| Location of Construction: 70-72 GRANT STREET | Owner: *** JEFFREY HA | M 114 LELAND STREET PO | one: ORTLAND ME**** | Permit No: |
| REPLACE EXISTING FRON STE | PS LEADING TO 70 & 72 | Action: Appro | oved U | Special Zone or Reviews; Shoreland OK with Wetland Conduction Flood Zone |

City of Portland, Maine – Building or Use Permit Application 389 Congress Street, 04101, Tel: (207) 874-8703, FAX: 874-8716

| | BUILDING PERMIT REPORT |

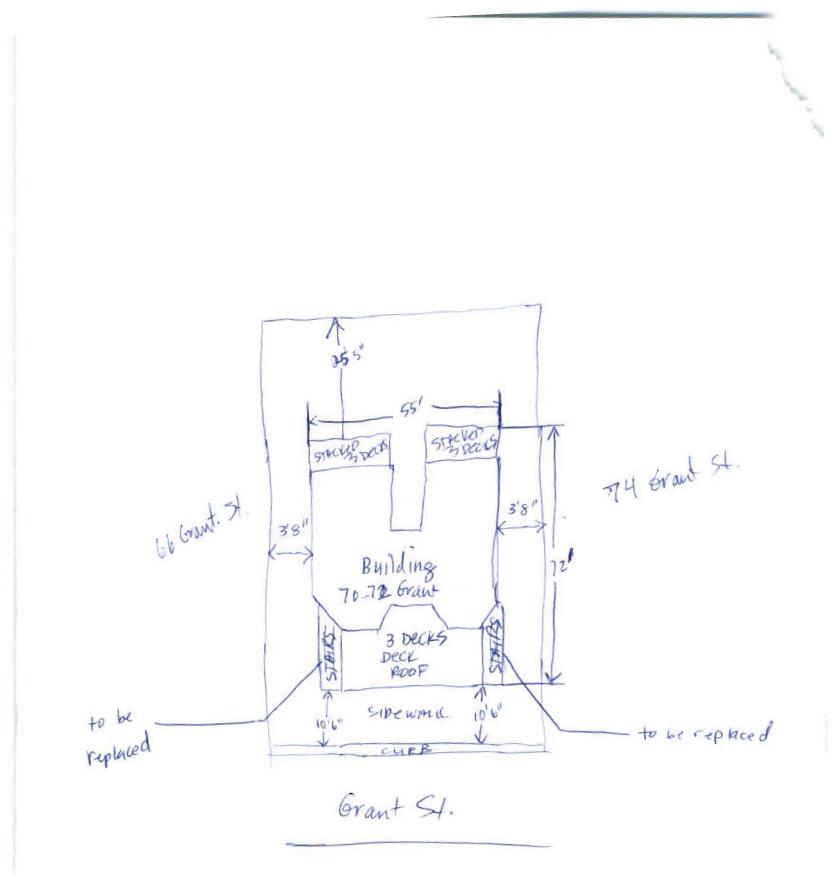
understanding the Long Ted Site Grait 437 ZY 15 m To Tha T. due STAIdande The pre KISE-S an INOT meet bldg. All other 1101 Code requireme Under 500 P Shall be adhere Too

IST Floor of front deck: replace decking with 5/4 PT Decking replace 2X8 joists as NeeDED SHOWN ON PRAYERS.

All material PT żxy" railings: top railing 2"xy" BALLISTE 1/2×1/2" - z'xy" 42" high 4" or less between balloters I" between bottom of railing and stair treads. 10" tread STAIRS steps" are 5'6" were 71/2 riser STEPS! supported by 4 - 2×12PT stringers existing pouved concrete sty system doesn't allow treads to be any wider. existing DECK' BOTH SET, OF STEPS LEAD TO A 8'X 27'Deck 2×8 PT 16" \$ 0,C W) JOIST HANGERS 5' * replacing all deck boards * * and existing 2x8 joist that are rotted. will be replaced with 288PT
